SHEA HOMES
603 South Valencia Avenue
Brea, California 92823

May 18, 2005
Work Order 500653

Subject: **GEOTECHNICAL REVIEW OF
40-SCALE ROUGH GRADING PLAN**
Tentative Tract 16187
2800 North Farmers Drive
City of Santa Ana, California

PROJECT ADDRESS:
 2800 N. FARMERS DRIVE
 SANTA ANA, CA.
ROUGH GRADING PLAN
TENTATIVE TRACT 16187
 PUBLIC WORKS AGENCY
 CITY OF SANTA ANA
 SHEET 2 OF

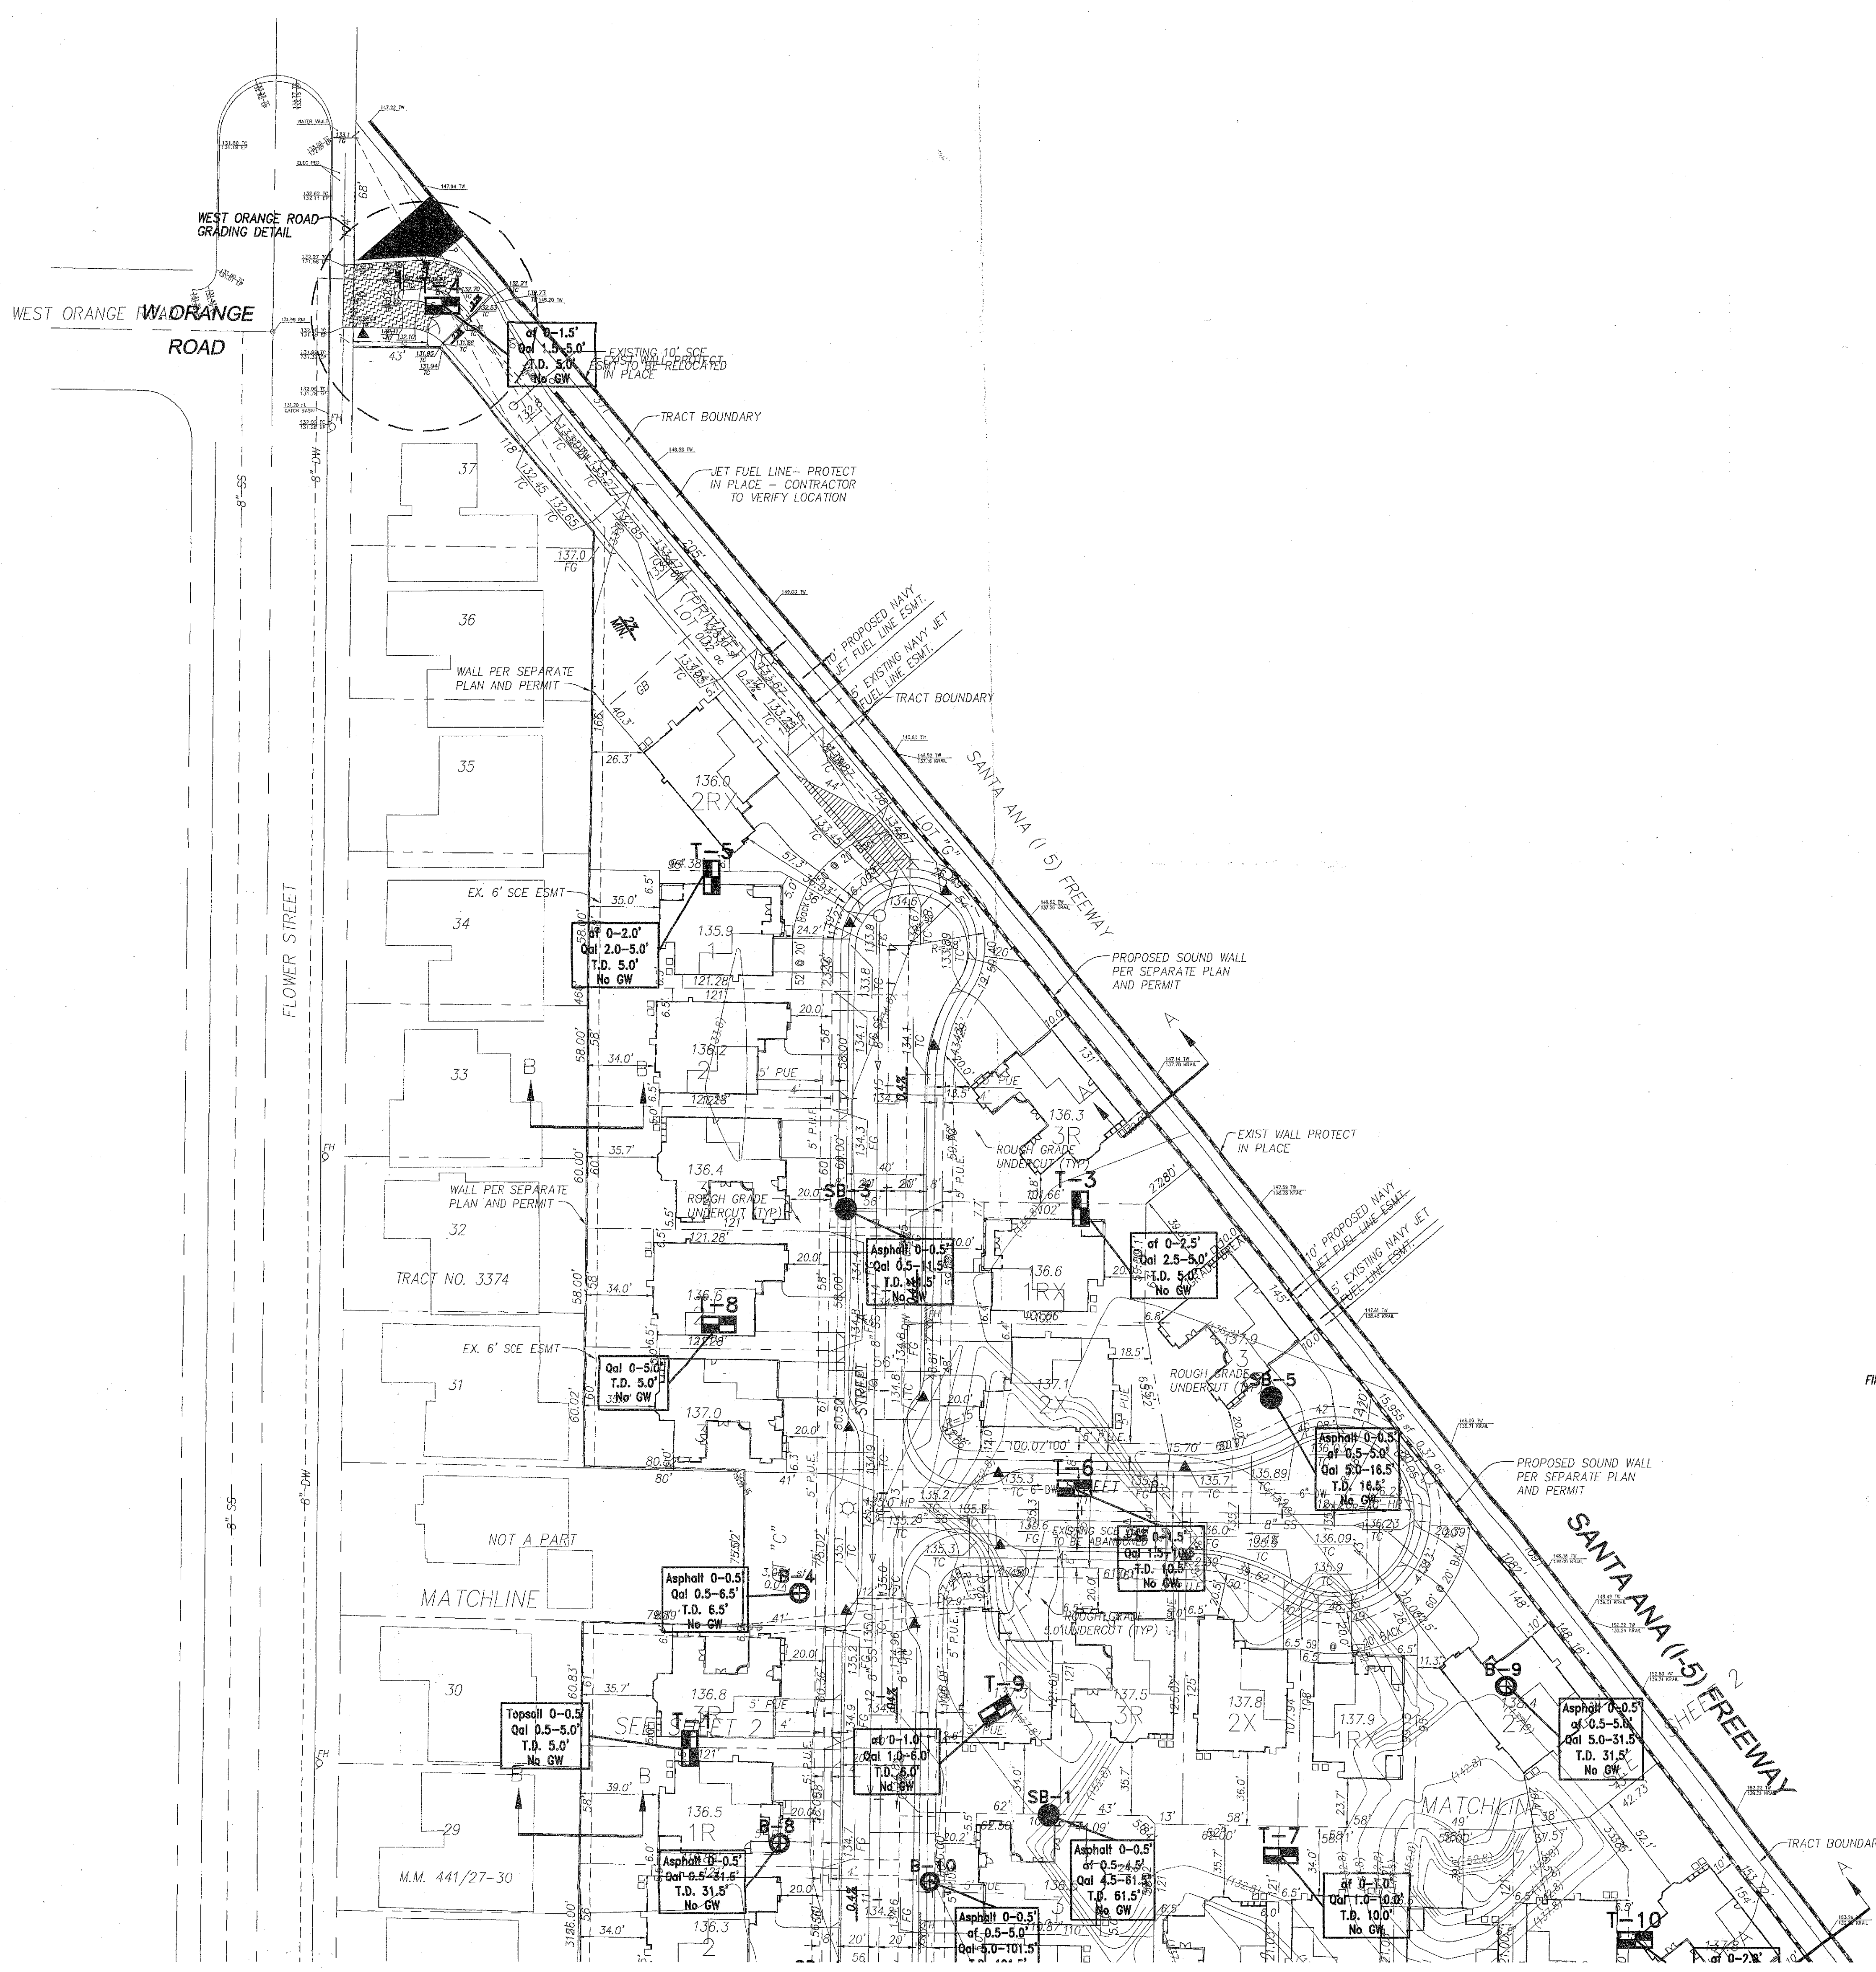
- Existing fill and underlying topsoil or unsuitable alluvial deposits should be removed. Generally, removal depths are anticipated to extend one (1) to five (5) feet below the current grade.

- Building areas should be overexcavated a minimum of five (5) feet below pad grade and street and parking areas two (2) feet below the subgrade.
- Numerous pieces of geotechnical fabric mixed with crushed asphalt associated with demolition of the existing parking lot were encountered at the site, generally within approximately 6 inches of the surface. From a geotechnical perspective, PSE does not object to incorporating this material into fill due to the limited quantities of this material. However, from an aesthetic perspective, the presence of this material in the compacted fill may not be appealing to homeowners; therefore, PSE recommends that this material be collected and incorporated into the compacted fill placed within street areas.

- It is PSE's understanding that the pre-existing building was demolished and that concrete portions were crushed on site. Provided that the material meets the gradation and durability requirements for crushed miscellaneous base (CMB), PSE has no objection to its use. This material may also be incorporated into compacted fill; however, the placement of this mixture should be limited to within street areas or within building areas provided that it is greater than three feet below the finished grade in building areas.

According to the Rough Grading Plan, it is proposed to found the sound wall on 18-inch diameter caissons. The passive resistance to be used in the design should be 350 psf/foot to a maximum of 4,000 psf. Lateral bearing of the upper two feet
